**RE: Response to Disapproval  
Marketing Tank Farm Laser-Induced Fluorescence/Hydraulic Profiling  
Investigation Report  
Western Refining Southwest Inc., Marathon Gallup Refinery  
EPA ID #NMD000333211, HWB-WRG-21-007**

### **ATTACHMENT A. RESPONSE TO COMMENTS**

**New Mexico Environment Department (NMED) to Marathon Petroleum Company (MPC) Comment Letter “Disapproval Marketing Tank Farm Laser-Induced Fluorescence/Hydraulic Profiling Investigation Report” (June 2, 2021)**

**FIGURE 3-1**

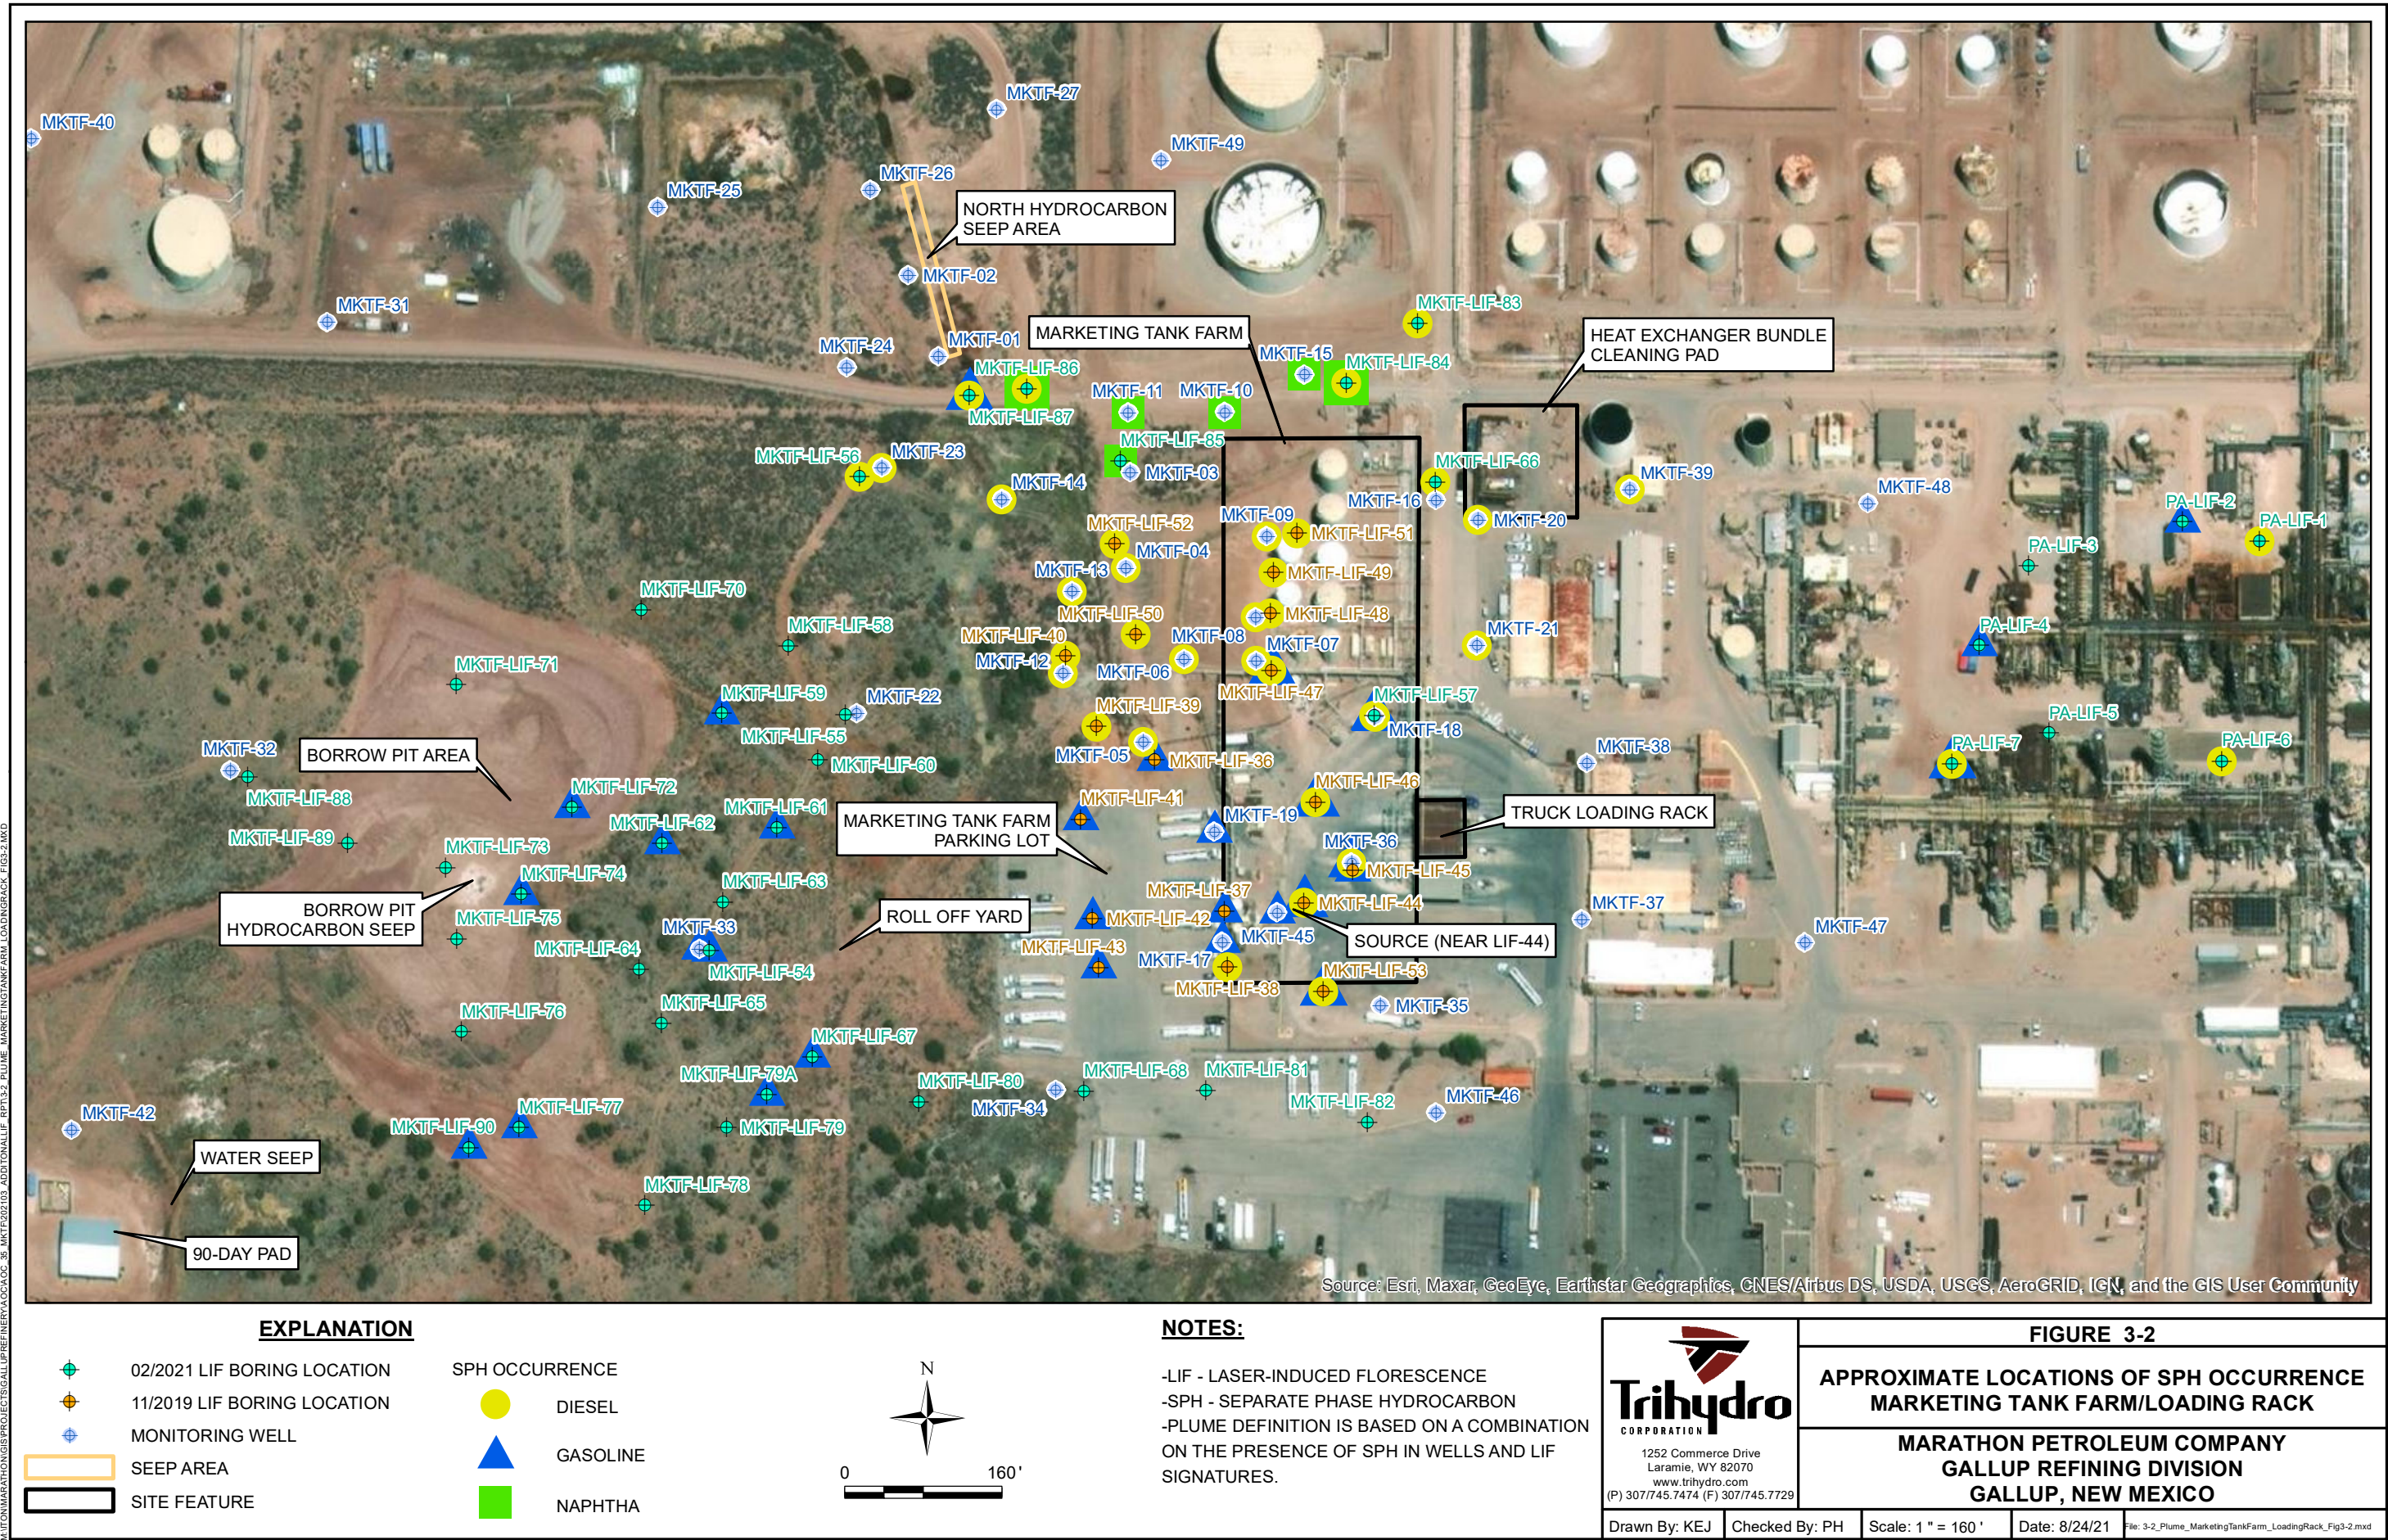
NMED Comments	MPC Responses
<b>Comment 11:</b>	<b>Response 11:</b>
<p>Section 3.1, <i>Laser-Induced Fluorescence Results</i>, pages 11 through 13, discusses the LIF results for borings designated as MKTF-LIF and PA-LIF. Figure 3-2 also presents borings designated as EB-LIF that were advanced in the vicinity of Tank 572. Elevated % RE signals were observed from these borings according to Appendix C. However, the Report does not discuss the results collected from the borings designated as EB-LIF. Revise the Report to include the discussion for the data collected from the borings designated as EB-LIF.</p>	<p>The boring locations designated as EB-LIF have been removed from the figures for this report. A discussion of the EB-LIF borings is included in the Sitewide LIF/HP Report, which will be submitted to NMED on or before October 31, 2021.</p>
<b>Comment 12:</b>	<b>Response 12:</b>
<p>In Section 3.1, <i>Laser-Induced Fluorescence Results</i>, page 12, the Permittee states, “[a] classic gasoline waveform appears in MKTF-LIF-37 below approximately 6 ft bgs.” According to the MKTF-LIF-37 log included in Appendix C, elevated % RE signals are observed at the depth intervals of approximately 5 - 17 feet bgs and 22 - 29.5 feet bgs. Although elevated % RE signals were detected at a termination depth of 29.5 feet, boring MKTF-LIF-37 was not advanced to a deeper interval. Therefore, the vertical extent of the SPH distribution at boring MKTF-LIF-37 was not determined. The boring should have been advanced to the depth where % RE signals diminish. Include this provision in future LIF investigations. No response required.</p>	<p>This comment has been acknowledged. Due to the nature of the probe used to collect LIF/HP data, it is vulnerable to damage once it reaches tight or competent material. Because tighter, more competent material was encountered at the termination depth in MKTF-LIF-37, the boring was not advanced any deeper despite continued % RE signals due to probe refusal. Future efforts will include an attempt with a dummy tip to advance deeper. In addition, future reports will note if refusal is reached with the LIF/HP probe.</p>

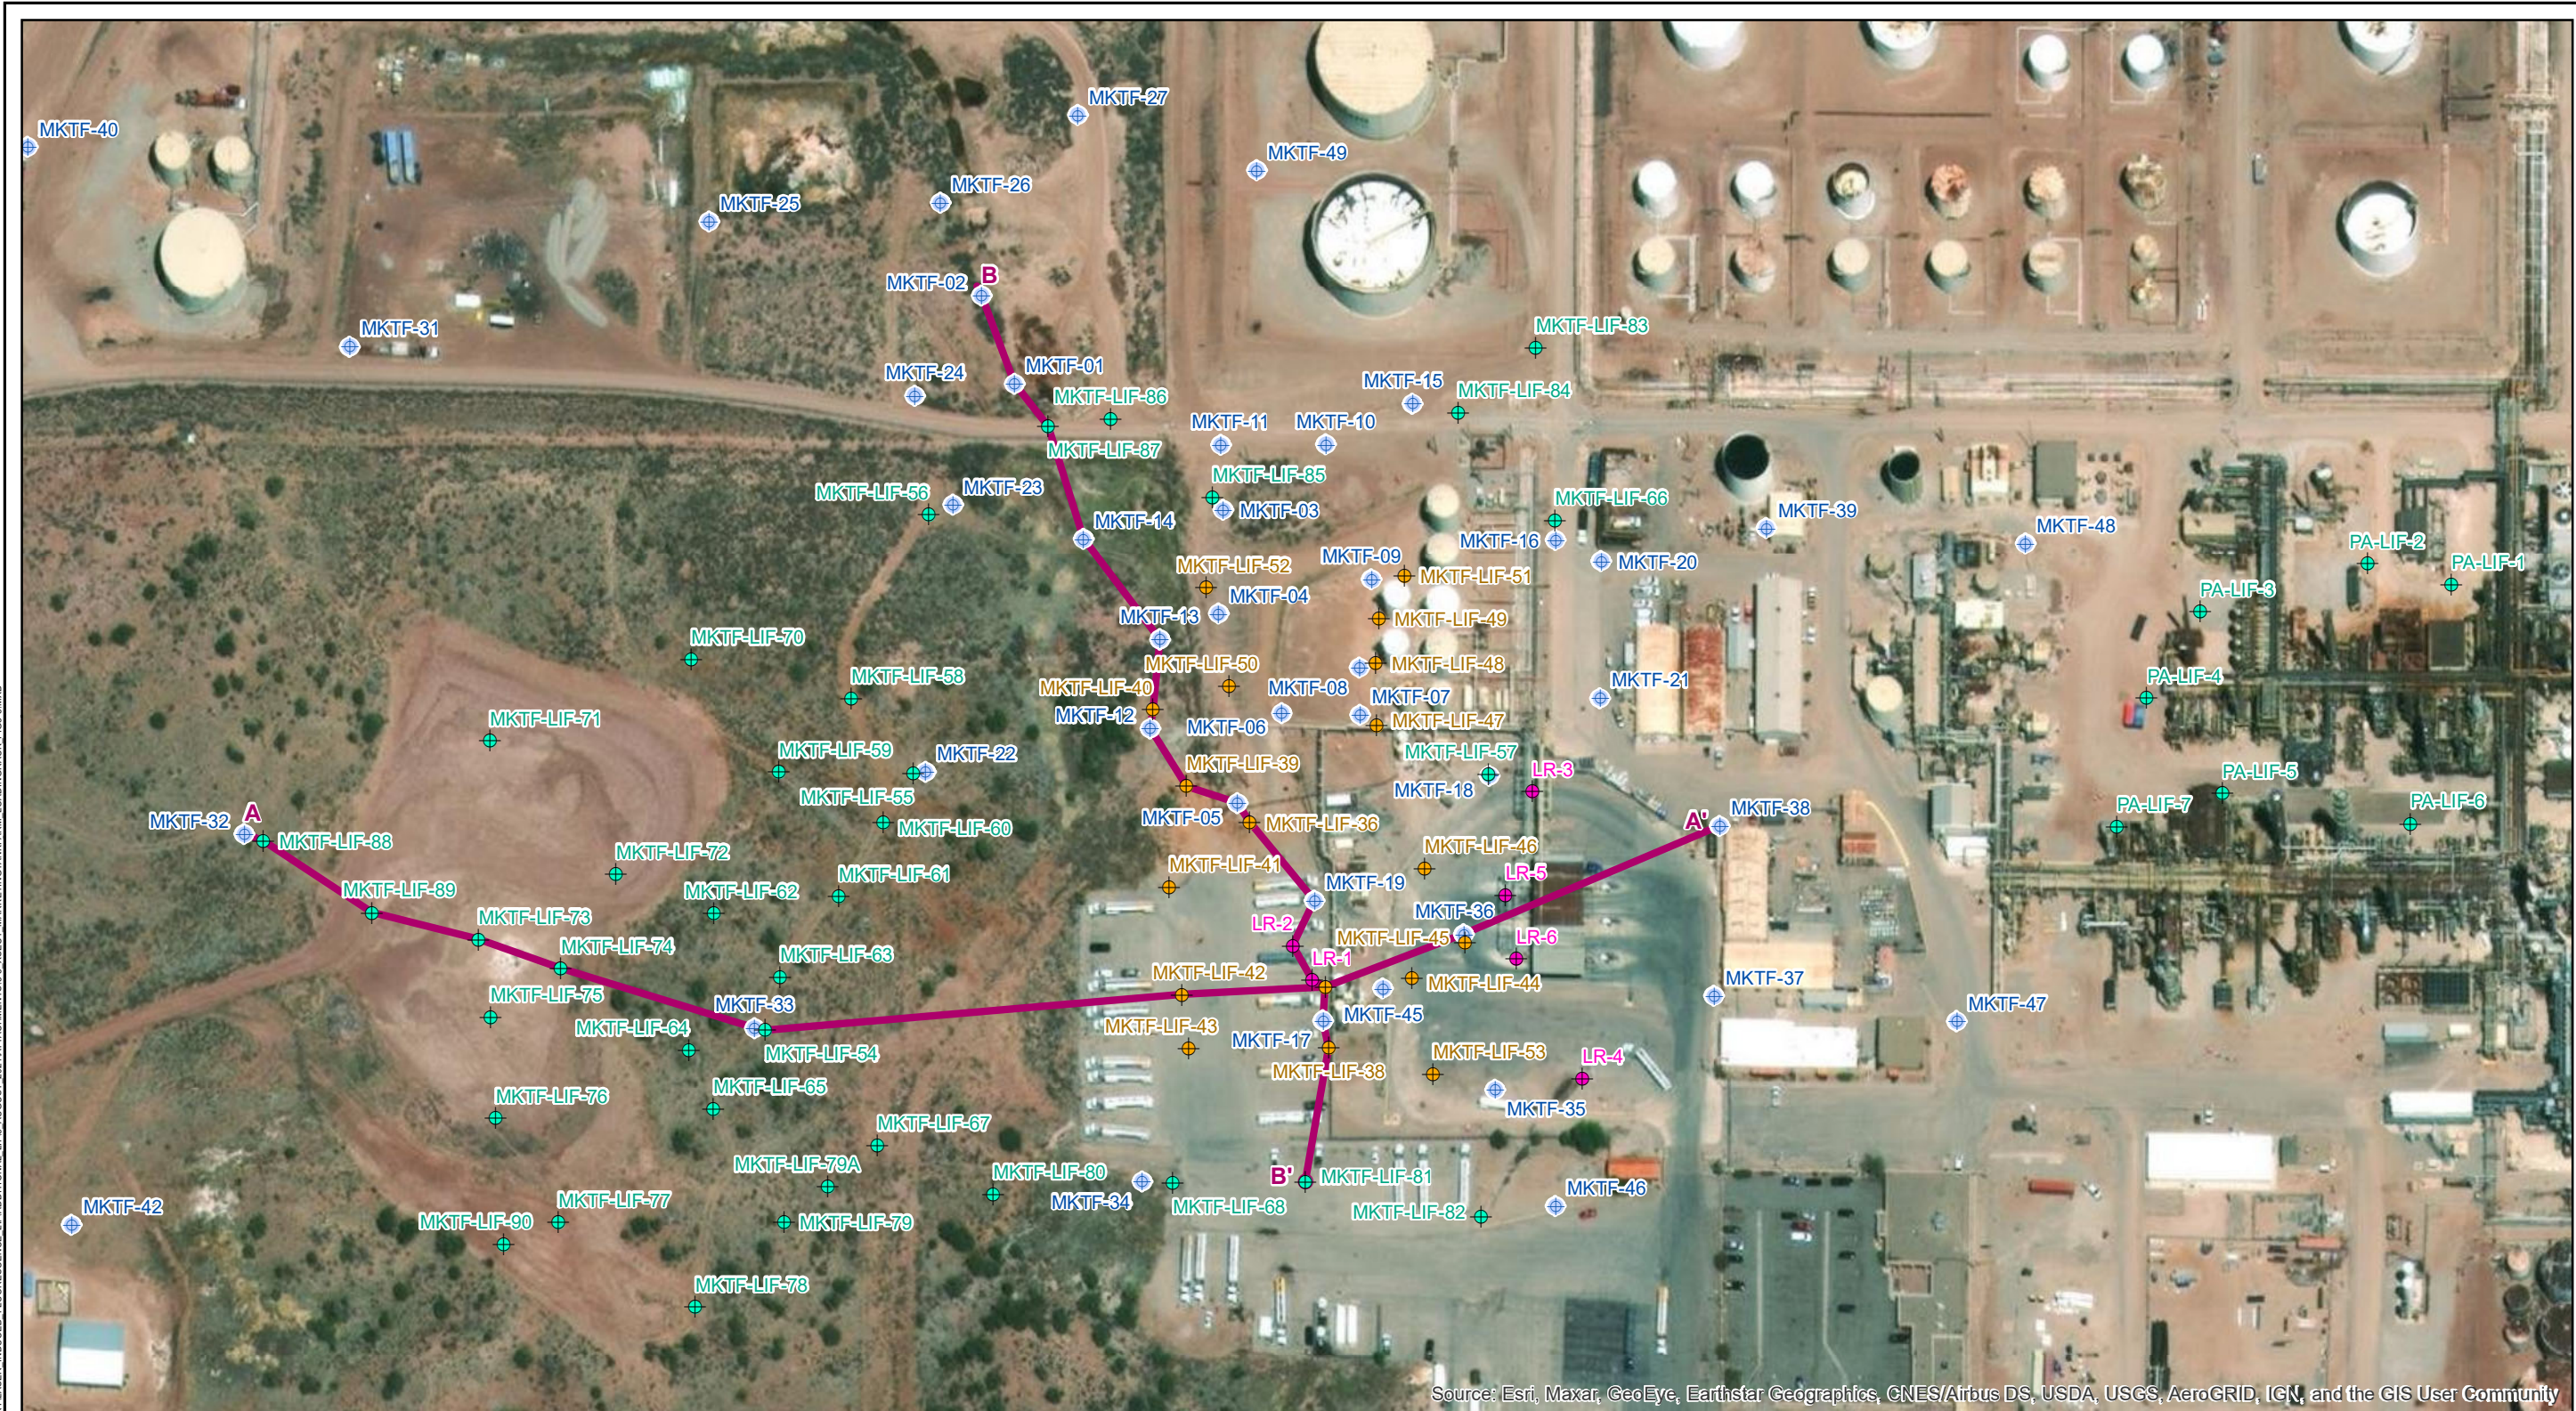
NMED Comments	MPC Responses
<b>Comment 26:</b>	<b>Response 26:</b>
<p>In Section 3.2, <i>Hydraulic Profiling Results</i>, pages 13 and 14, the Permittee states, “Figure 3-3 presents the cross-section location map; Figure 3-4 presents the cross-sections with maximum historical SPH thickness.” Figure 3-4 depicts the surface elevations of borings MKTF-LIF-42, MKTF-LIF-73, MKTF-LIF-74, MKTF-LIF-81, and MKTF-LIF-89; however, the LIF/HP logs included in Appendix C indicate that the elevations are unavailable, if the elevation data are available, include the data in the LIF/HP logs; otherwise, explain how the surface elevations were determined in the revised Report.</p>	<p>Elevation surface data were collected by Dakota using a GPS during the field event but were not included on the LIF/HP logs. The data are included Appendix D of the Sitewide LIF/HP Investigation Report, which will be submitted to NMED on or before October 31, 2021.</p>

<p>Figures 3-3 and 3-4 include historical borings designated as “LR”. Provide a copy of the boring logs in the revised Report. In addition, Figure 3-4 includes the cross section of 12 MKTF wells. A copy of these boring logs must also be provided in the revised Report.</p>	<p>Boring logs for LR-1, LR-2, and the MKTF wells shown on the cross section are included Attachment E.</p>
